SUBJECT: BRAIDWOOD STATION, UNITS 1 AND 2 – REGULATORY AUDIT SUMMARY
REGARDING LICENSE AMENDMENT REQUEST TO UTILIZE TVEL TVS-K
LEAD TEST ASSEMBLIES; (EPID L-2019-LLA-0208)

AUDIT REPORT BY THE OFFICE OF NUCLEAR REACTOR REGULATION

UTILIZE TVEL TVS-K LEAD TEST ASSEMBLIES

BRAIDWOOD STATION, UNITS 1 AND 2

Figure 2: RIA Empirical Database

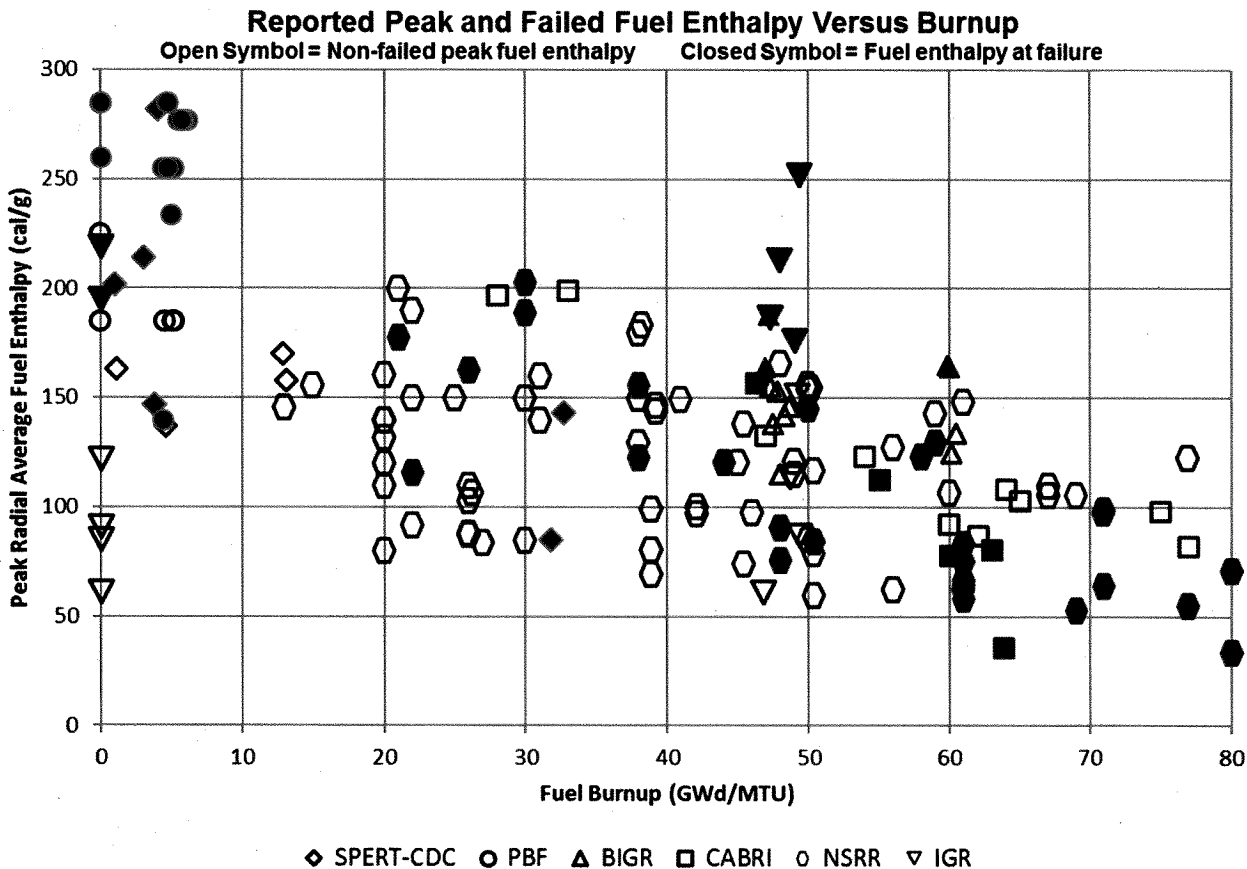
Figure 2 depicts the entire reactivity initiated accident (RIA) empirical database and represents decades of testing conducted around the globe. RIA testing conducted on VVER reactor fuel rods with UO₂ fuel pellets and E110 cladding at the Russian BGR and IGR research facilities are shown as triangles on Figure 2. In total, 26 RIA tests were performed at these Russian facilities. These test results have been deemed applicable by the NRC staff and have been used to generate the Interim RIA Acceptance Criteria and Guidance provided in Standard Review Plan, Chapter 4.2, Appendix B, Revision 4, dated March 2007 (ADAMS Accession No. ML070740002). Hence, E110 cladding is already addressed in existing guidance by virtue of inclusion of E110 testing in the database used to develop the current guidance.
